### Invitation to Tender No. 2023-PRC-06

### Arts and Heritage Hub ADDENDUM #4

# Tender Addendum TA004

**TA004 - RFI #2 – ITT No. 2023-PRC-06 – Arts & Heritage Hub**

## FCBT690

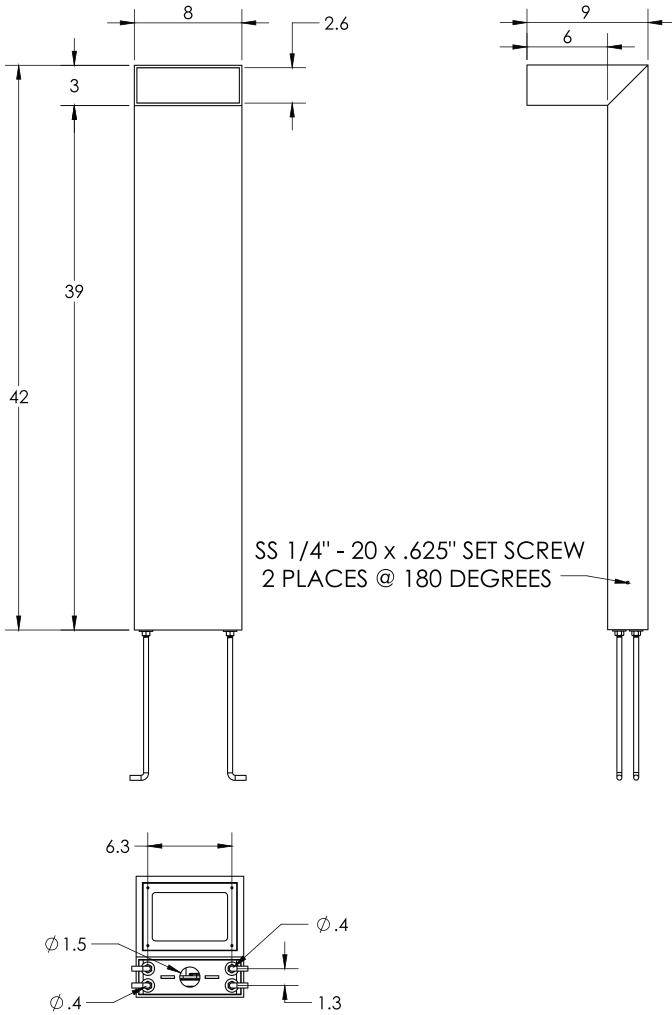
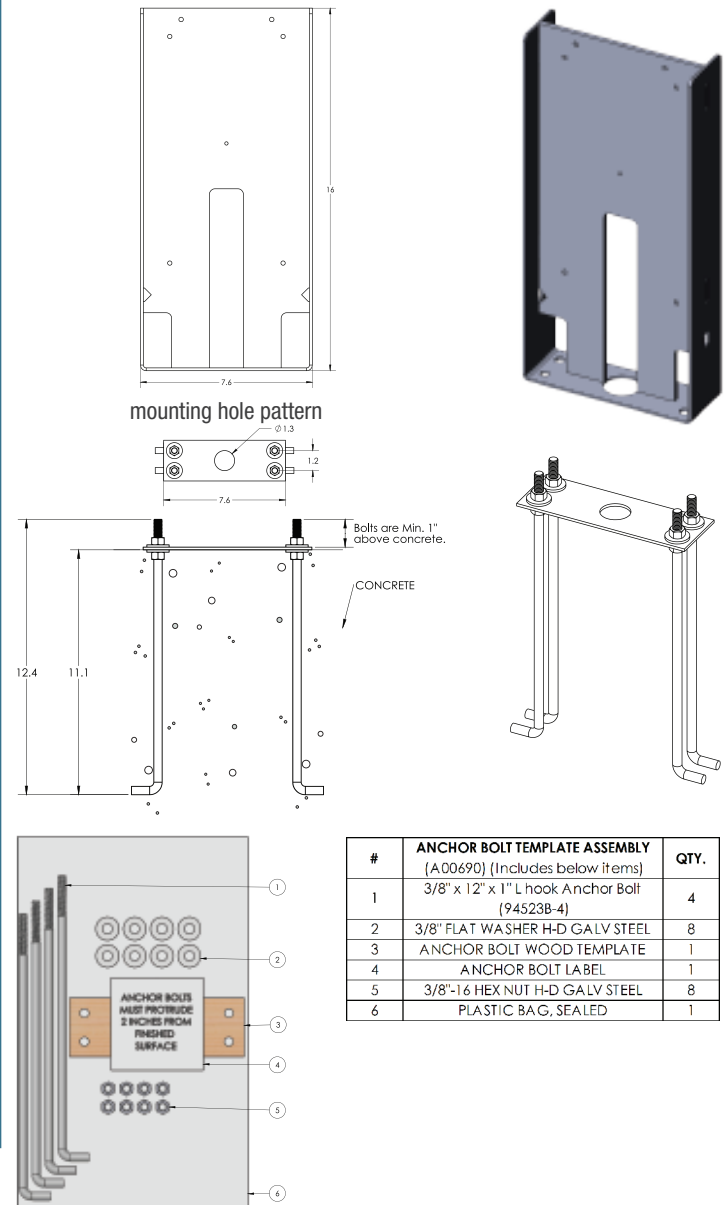
1. Please provide specs for the three bollard luminaires along the wood deck, and one square bollard post at the main entrance.

**A: FC Outdoor Lighting FCBT690. Please see attached cut sheet.**
